CACHE RIDGE SUBDIVISION-PHASE 1
PRELIMINARY PLAT
PLANNING COMMISSION MEETING
JANUARY 11, 2018
~530 NORTH 600 EAST

CACHE RIDGE SUBDIVISION
PRELIMINARY PLAT
500 NORTH 600 EAST
HYRUM, UT

PROPOSED CONDITIONS

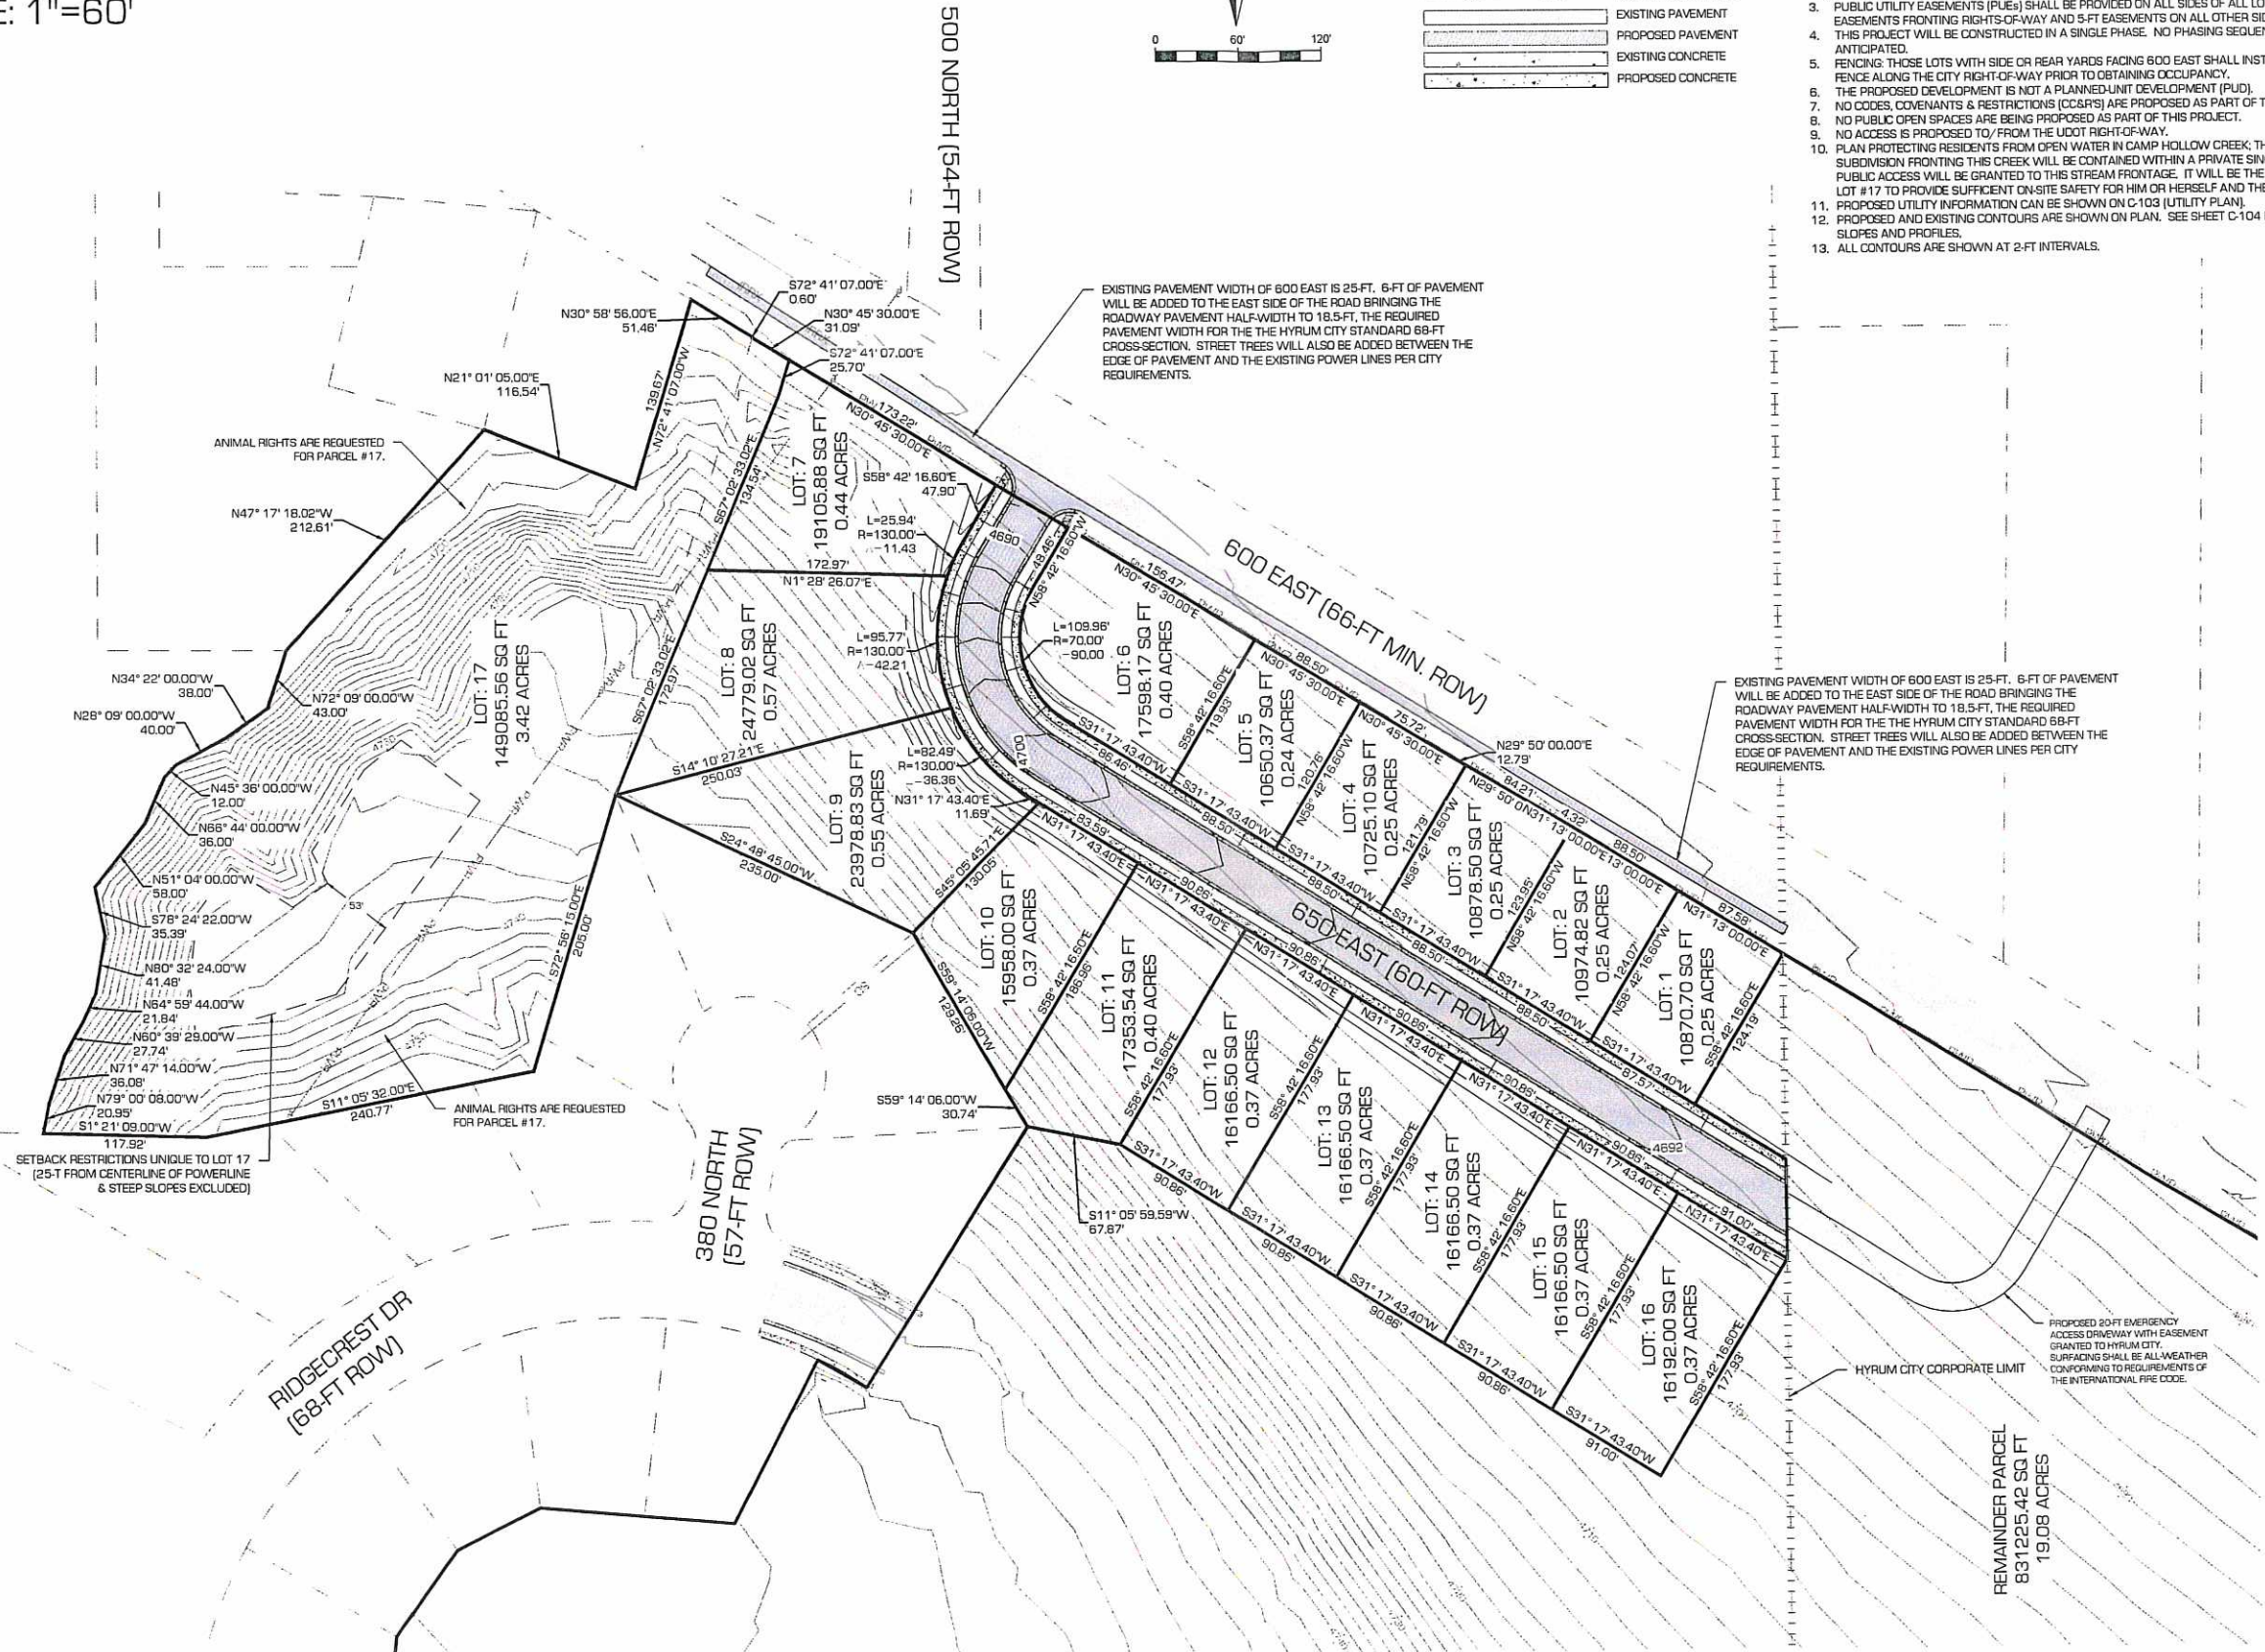
UTILITIES- Available on 600 East. They will need to loop the culinary water from Ridgecrest also to meet fire flow requirements as shown. Irrigation will require looping at some point but should be Ok for this phase.

STORM WATER- Sumps are being proposed at two locations as shown.

FENCING- 600 East is being required to be fenced. The plat is showing this as a six-foot-tall security fence. May want to require an exact type of fence so it is uniform. Also, do you want the developer to install or leave it as they have indicated on the plat that the homeowner does this before occupancy?

Lot 17 will be a large lot that enters off of 600 East with its own entrance and driveway. Will need to discuss utilities for that lot. Will future home builder be responsible for connections? It would be best to require culinary water and irrigation be stubbed to the property before the six feet of asphalt is installed on 600 East.
